ADDENDUM NO. 1

**TRI-COUNTY SCHOOL JR-SR HIGH SCHOOL BACKPACK ADDITION &
NEW MAINTENANCE FACILITY
Wolcott, IN 47995**

ADDENDUM ONE

Addendum One (AD.01) to the drawings and specifications prepared by Gibraltar Design for **Tri-County Jr/Sr High School Backpack Addition & New Maintenance Facility** for Tri-County School Corporation, Wolcott, Indiana.

15 1" BACKER ROD AND SEALANT EXPANSION JOINT

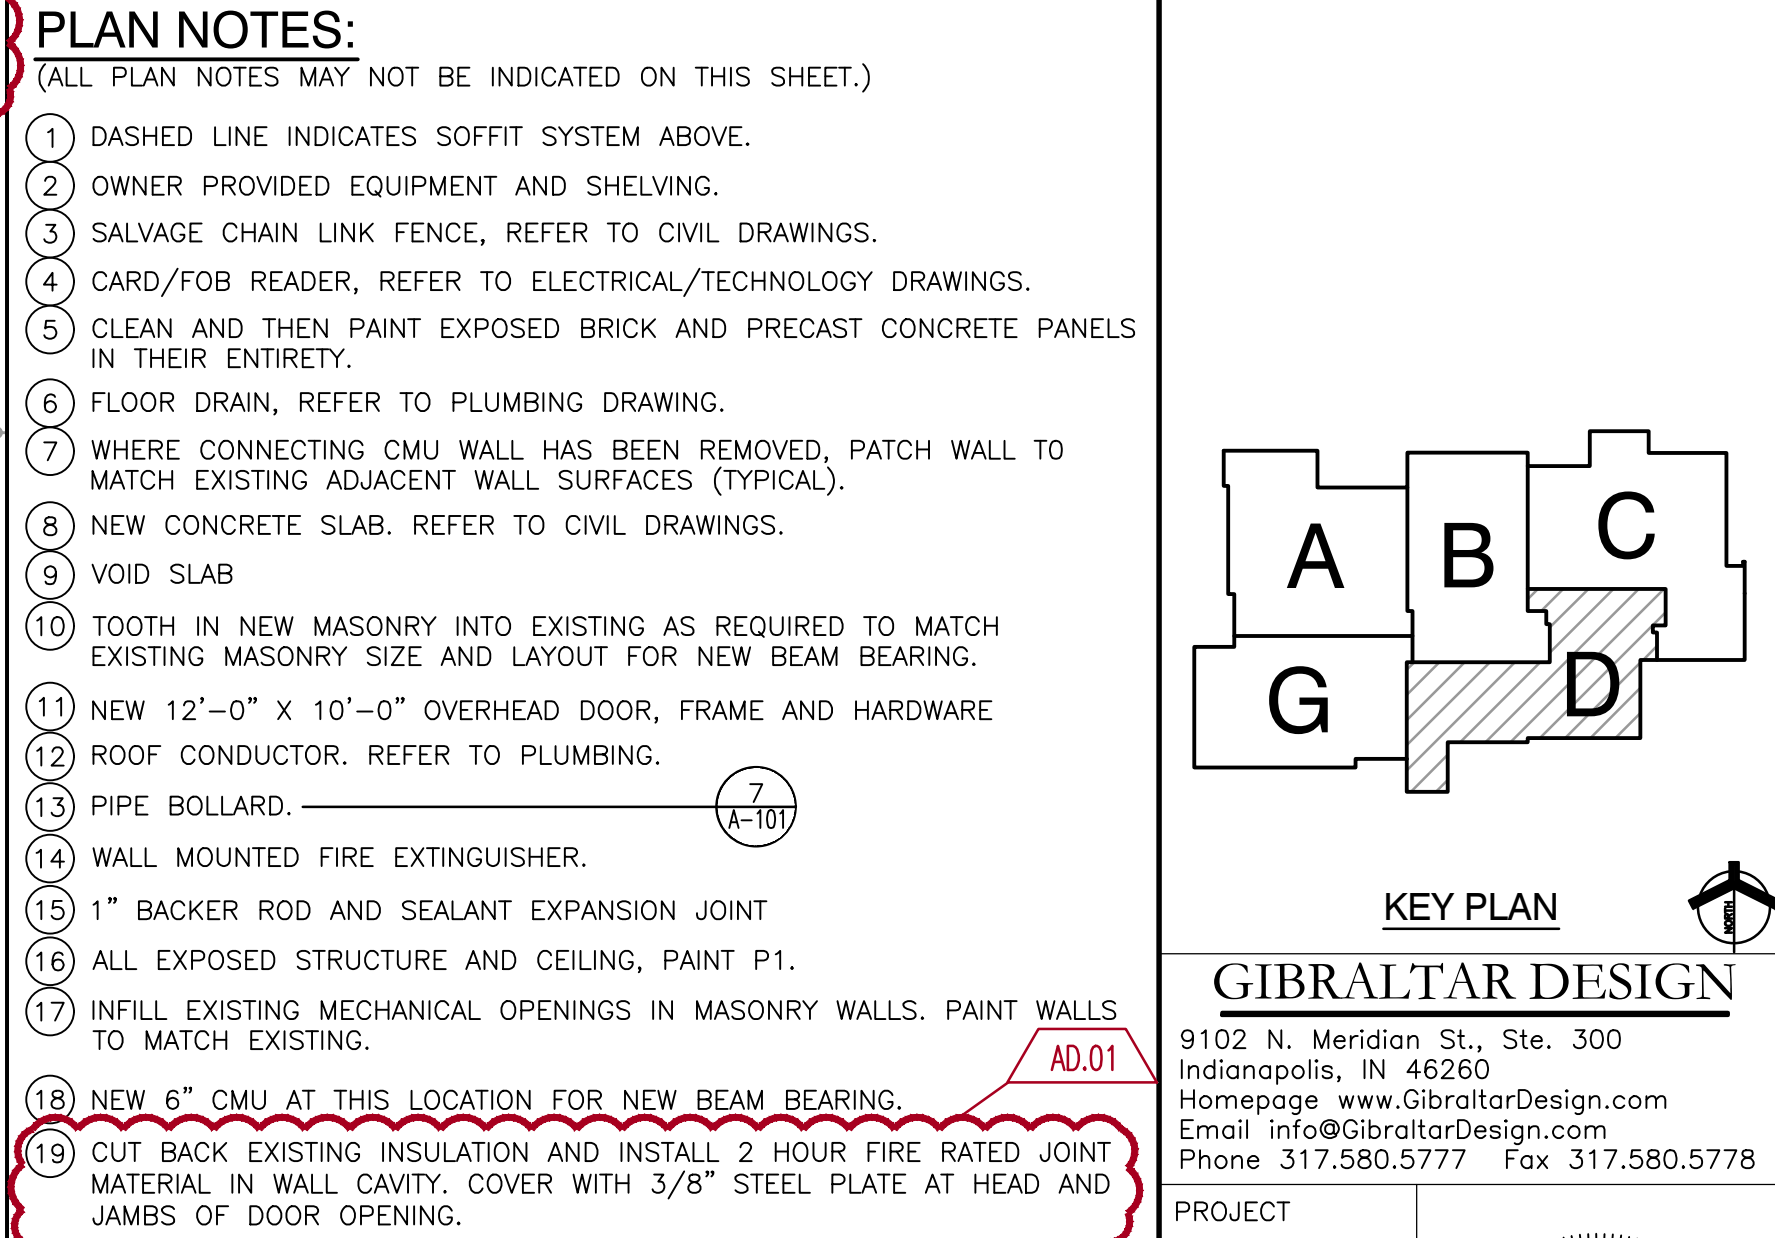
- A. Revised plan notes.

5. Sheet A-103

- A. Revised Wall section 2

6. Sheet M-001

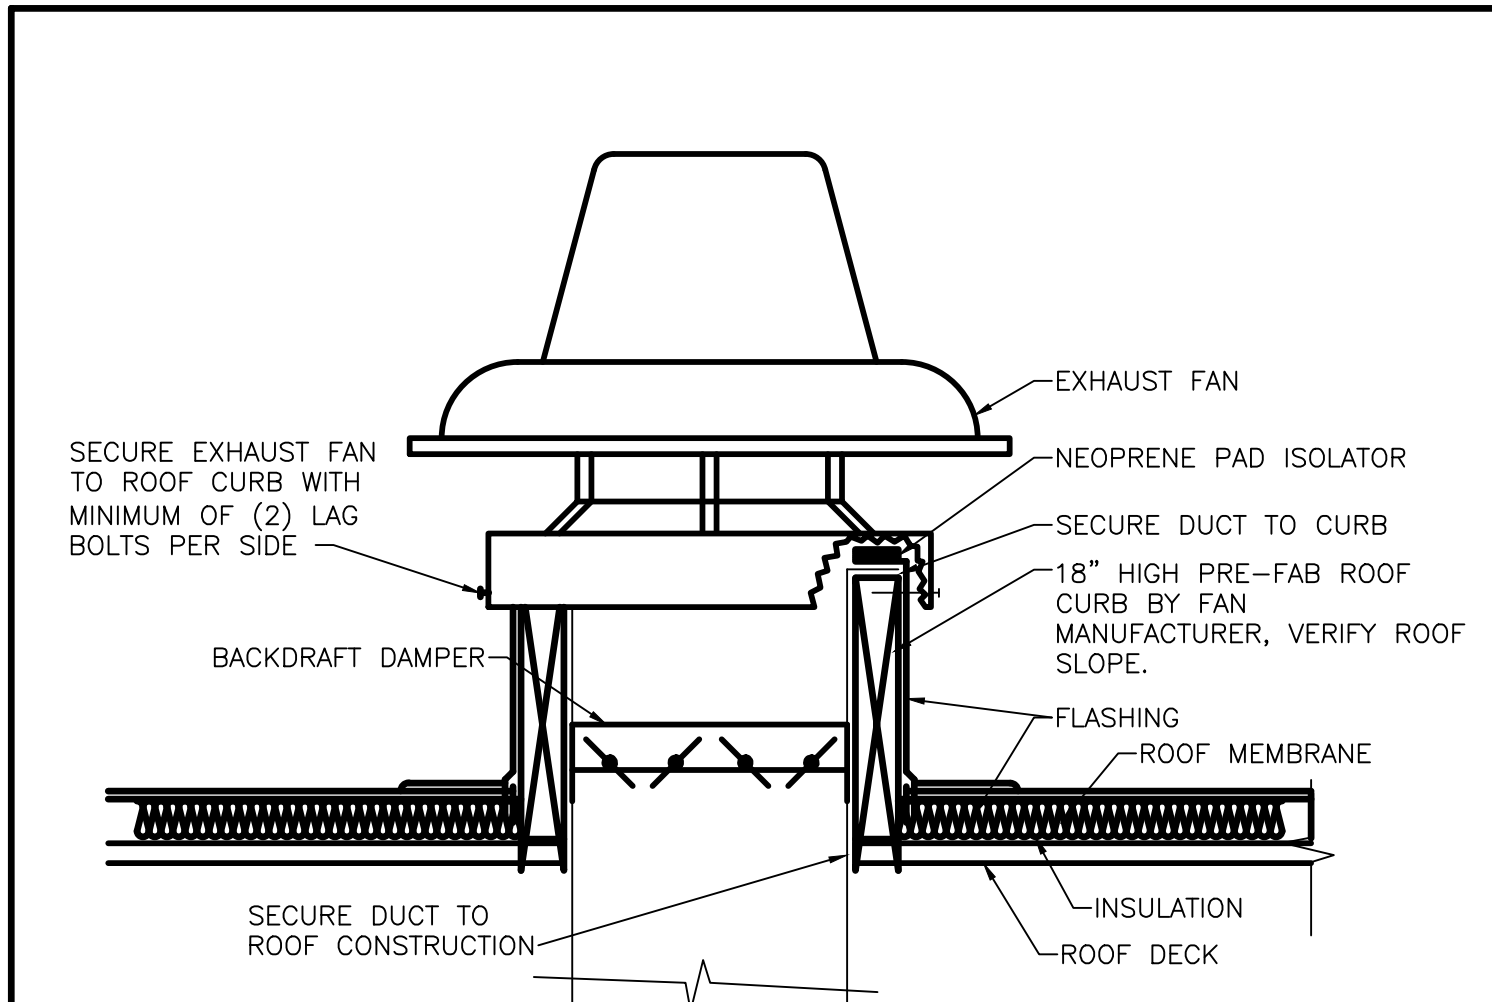
- A. Added EF-4 to Mechanical Equipment Schedule.
- B. Added Intake Hood Schedule.

INTAKE HOOD SCHEDULE						
TAG	MANUFACTURER	MODEL #	THROAT SIZE	DESCRIPTION	HOOD LOCATION	REMARKS
IH-1	GREENHECK	FGI	28x28	OUTSIDE AIR INTAKE HOOD FOR WELDING SHOP D-102	ROOF OF WELDING SHOP D-102	PROVIDE W/ BIRDSCREEN, 24" HIGH ROOF CURB, WASHABLE FILTERS, AND MOTORIZED DAMPER.

8. Sheet M-101

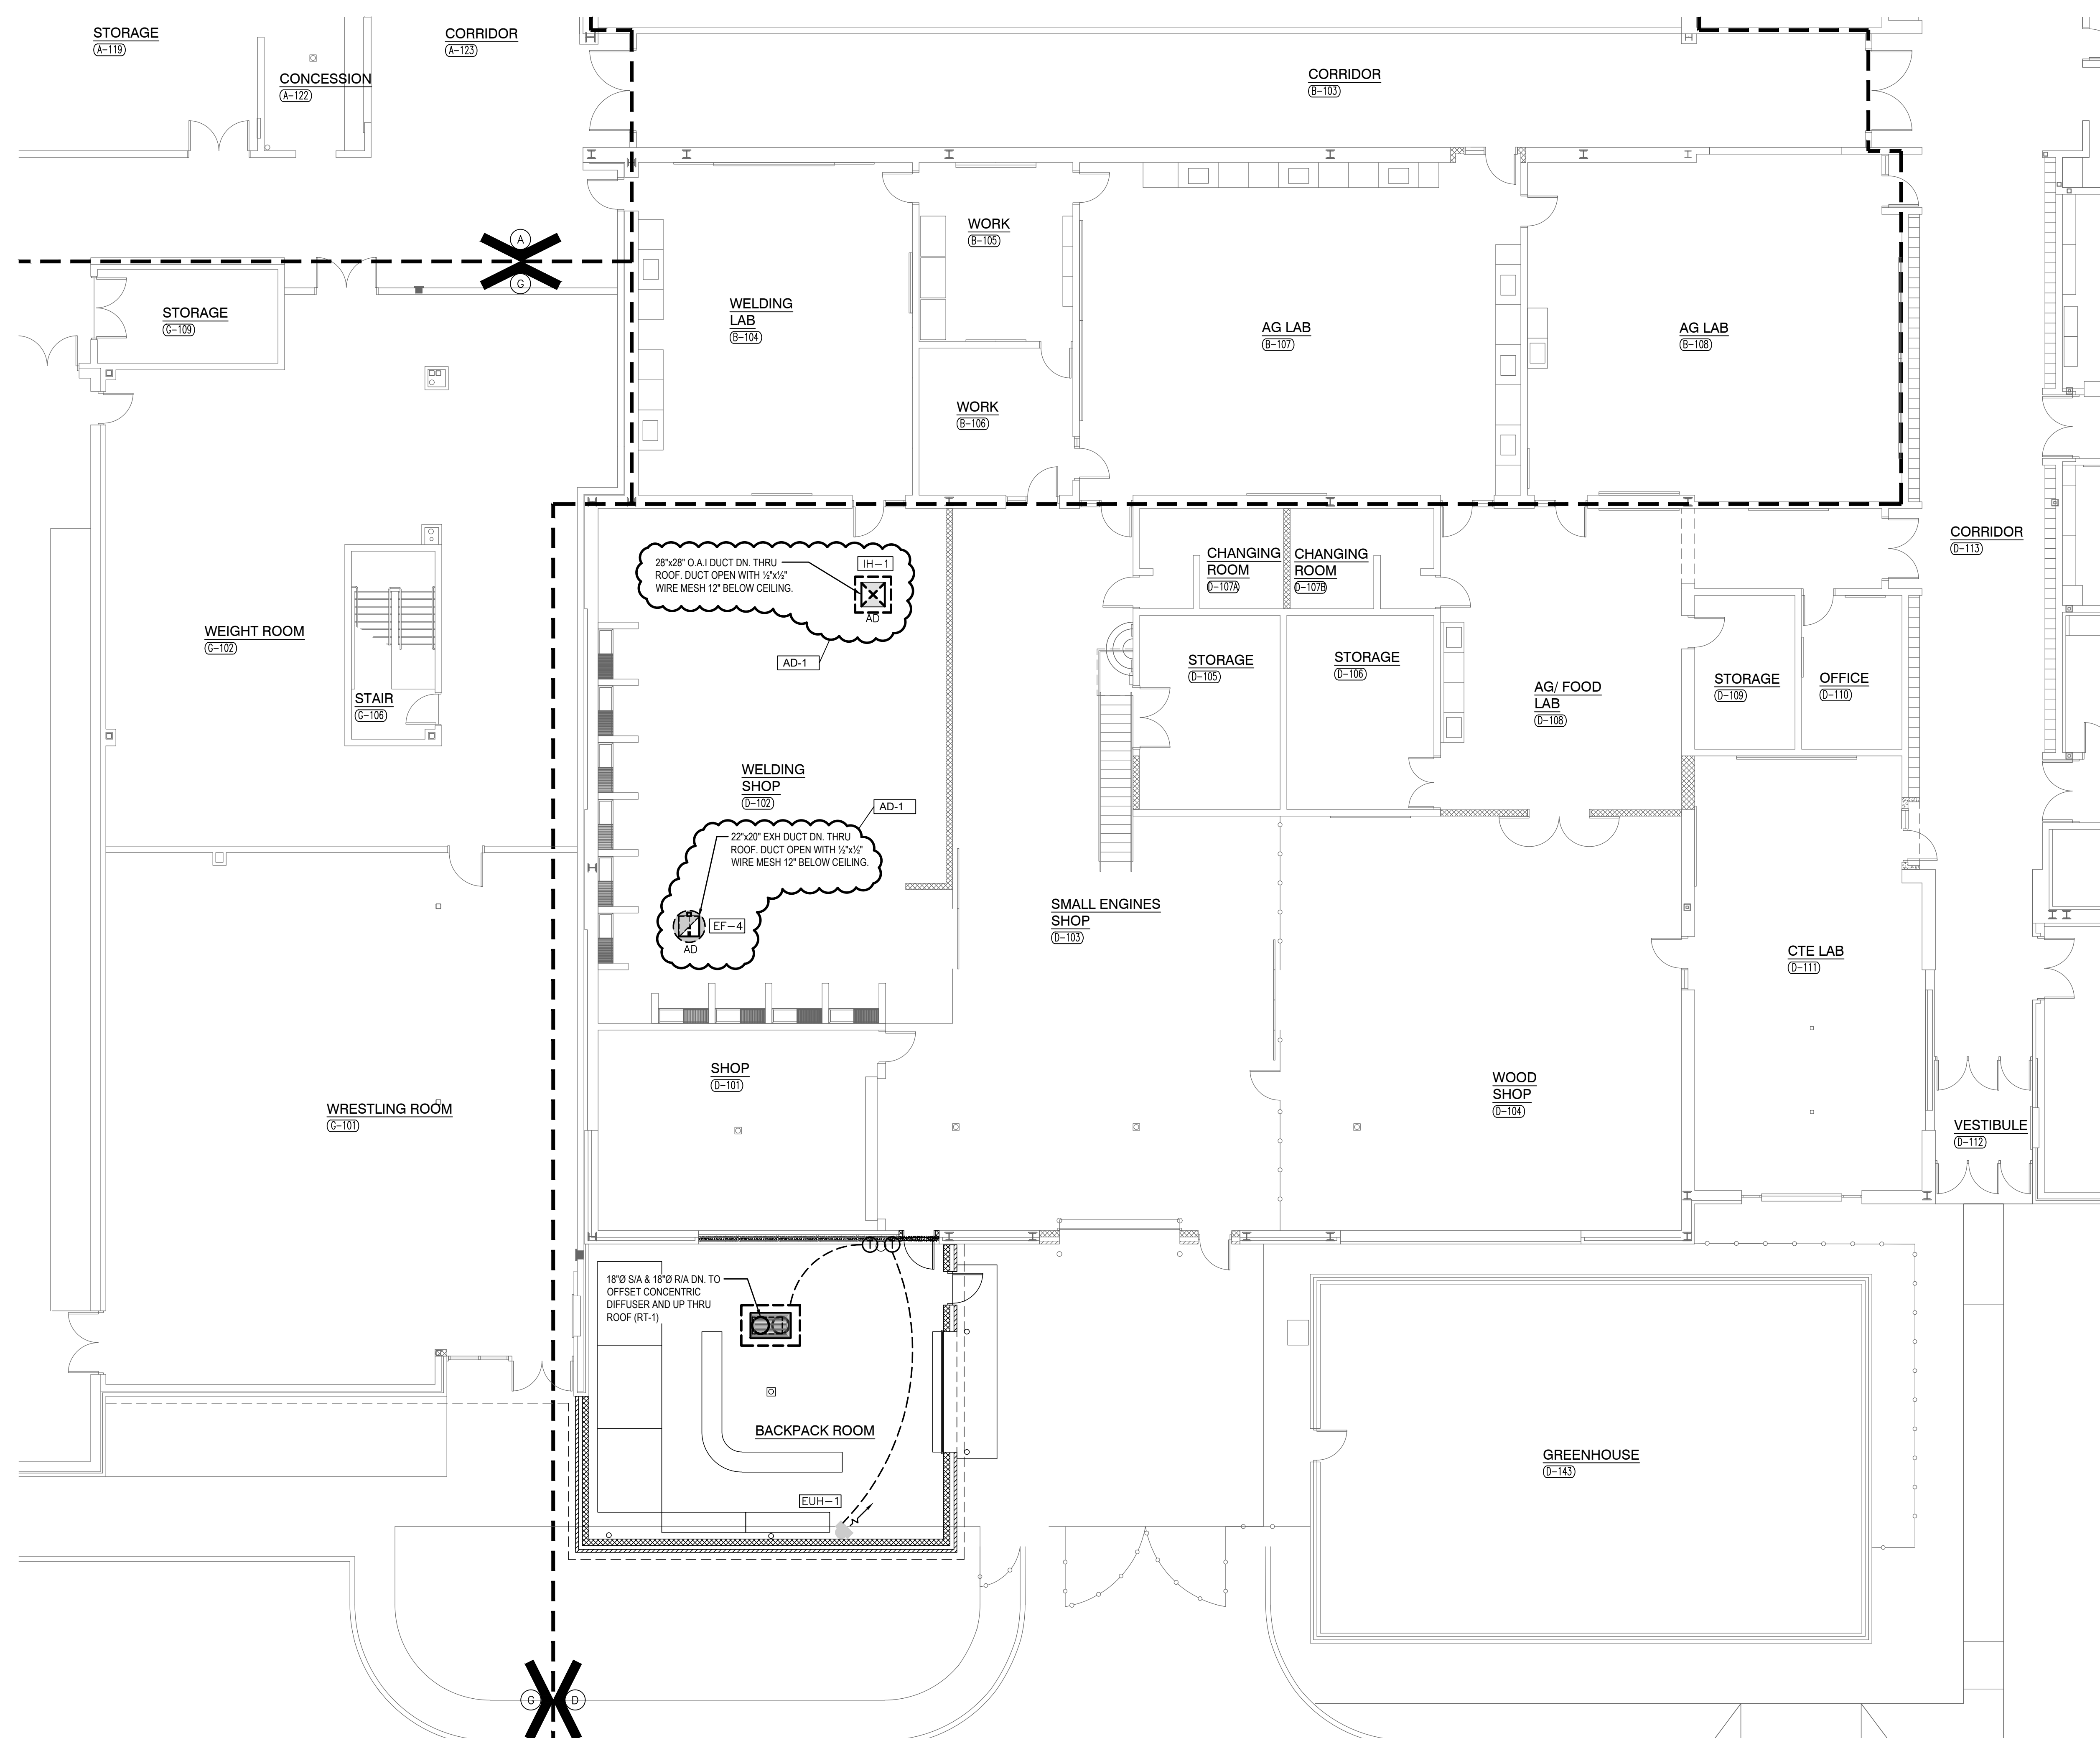
- A. Added EF-4 to roof of Welding Shop D-102.

- B. Added IH-1 to roof of Welding Shop D-102.

9. Sheet E-101

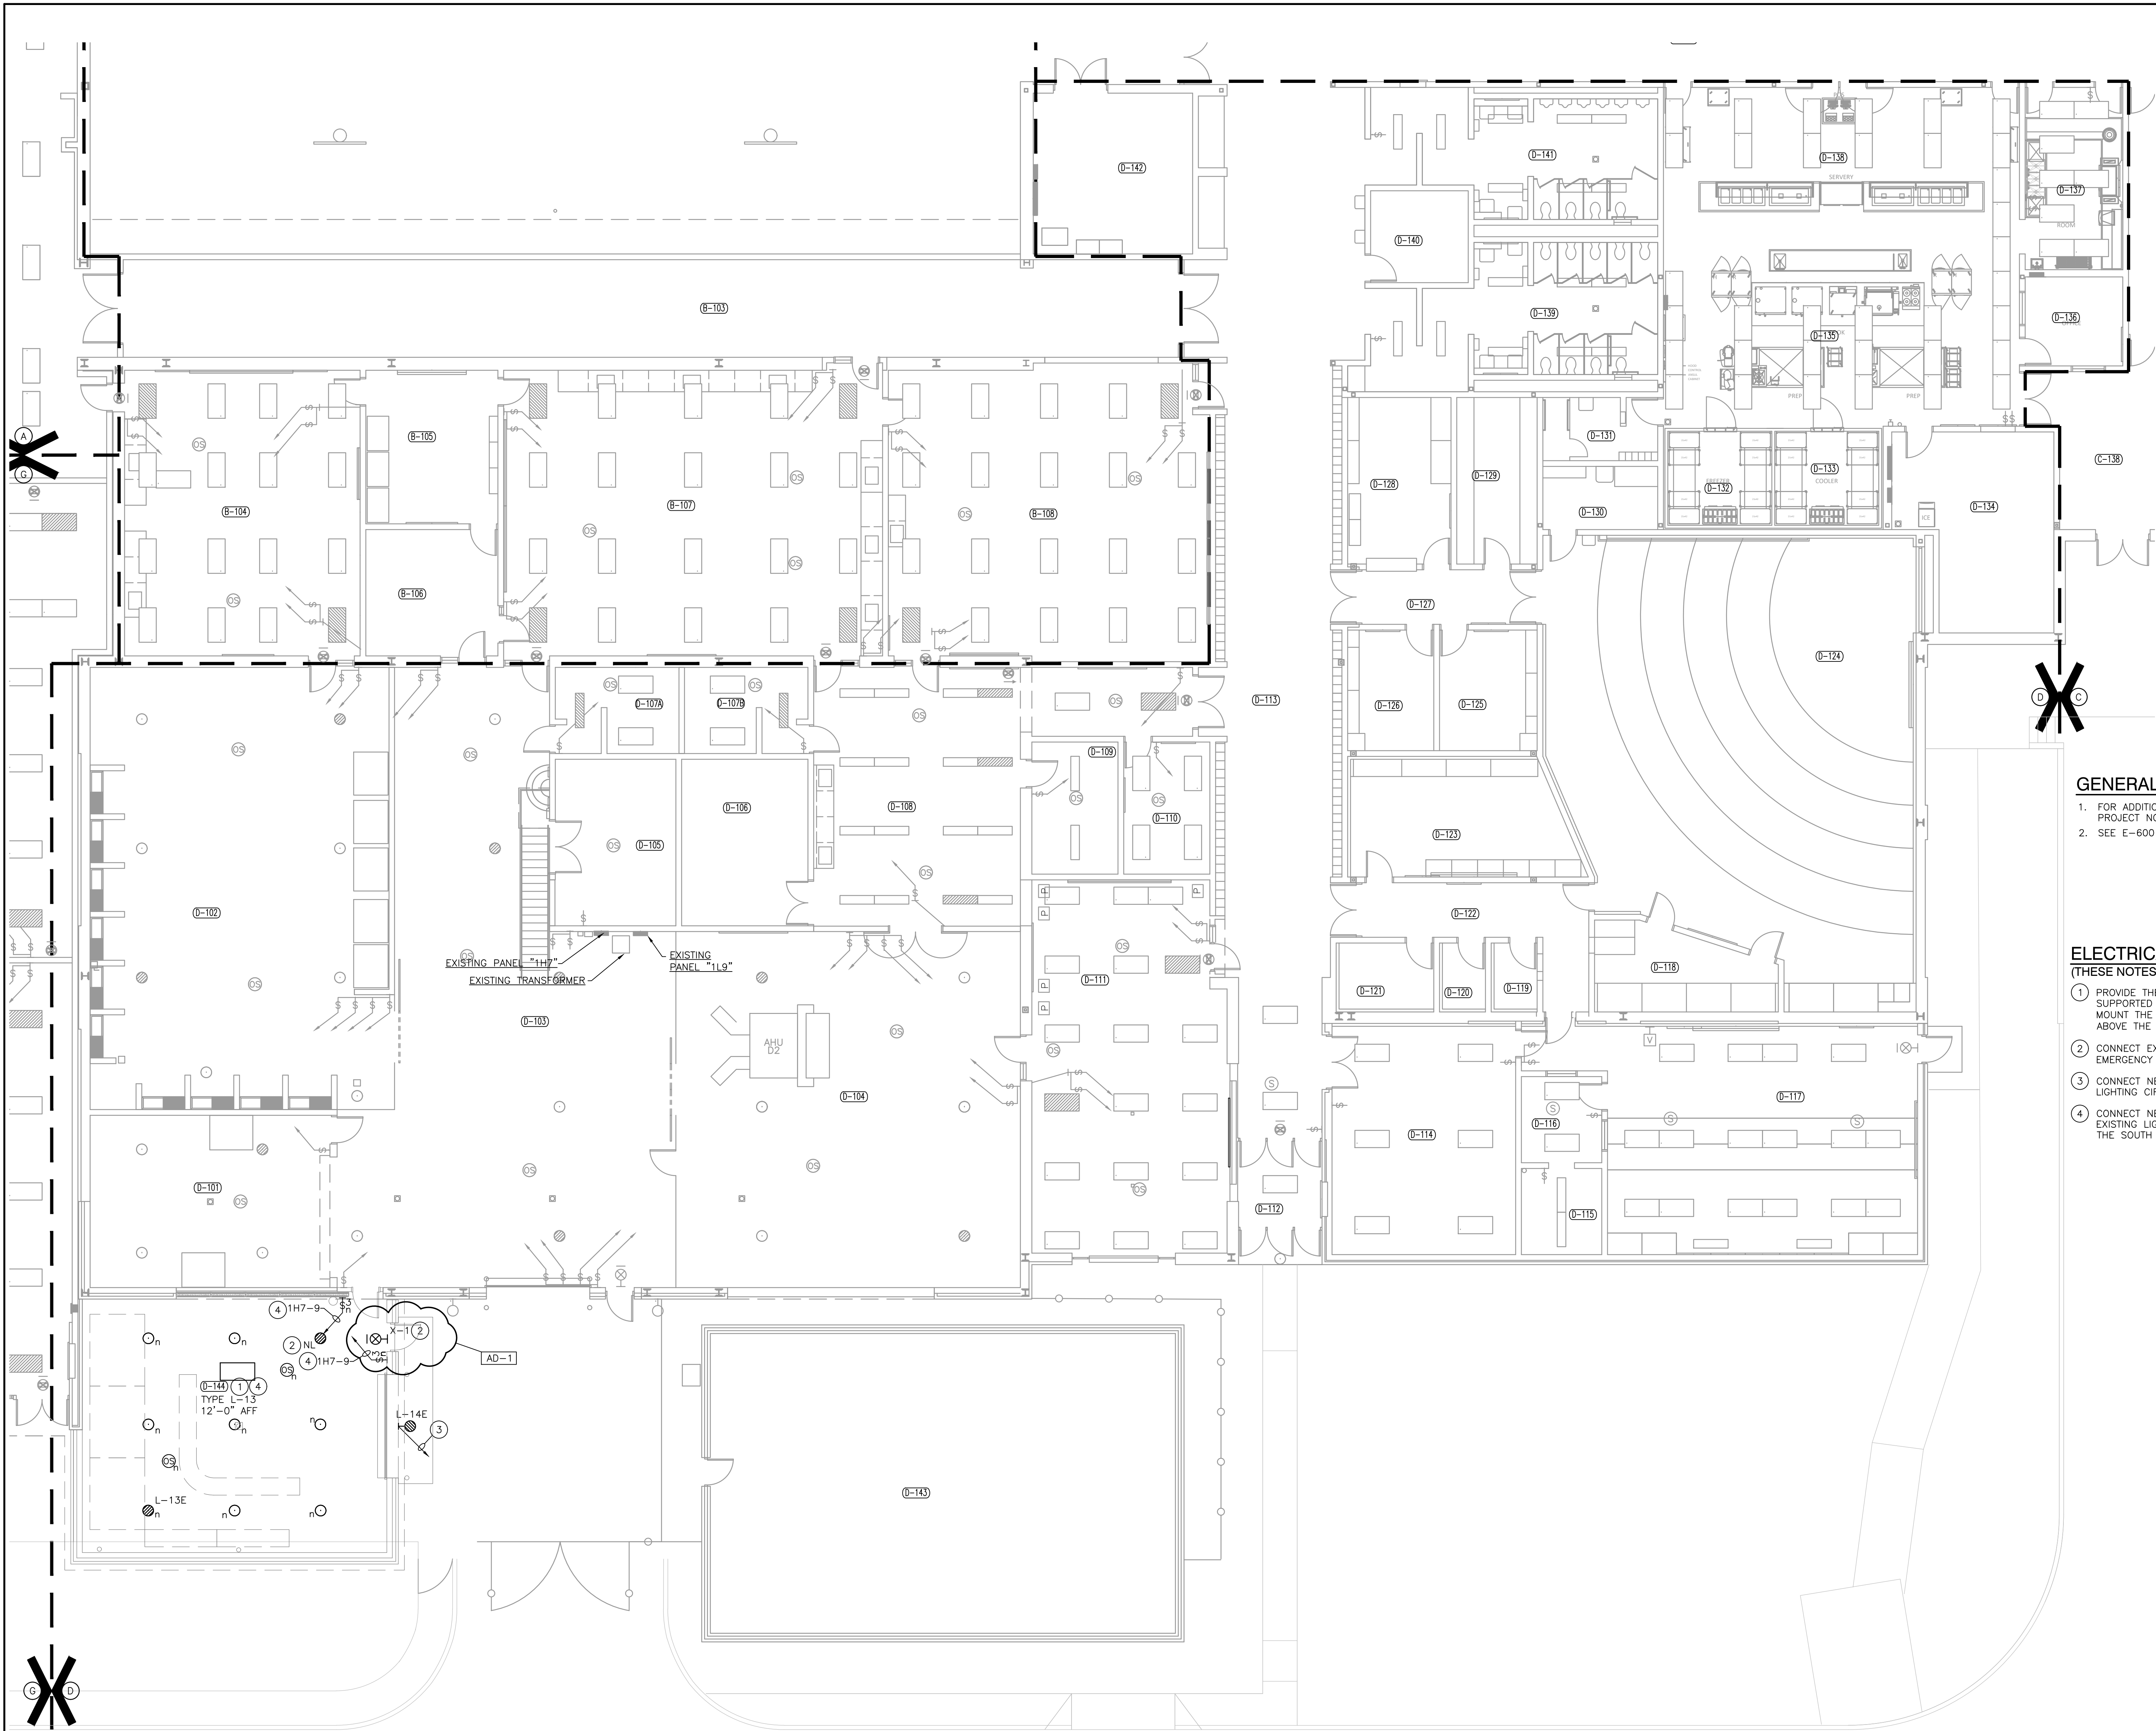
- A. In Backpack Processing D-144 deleted power circuit shown to the exit sign. Exit sign is to be connected to the existing emergency lighting circuit serving this area.
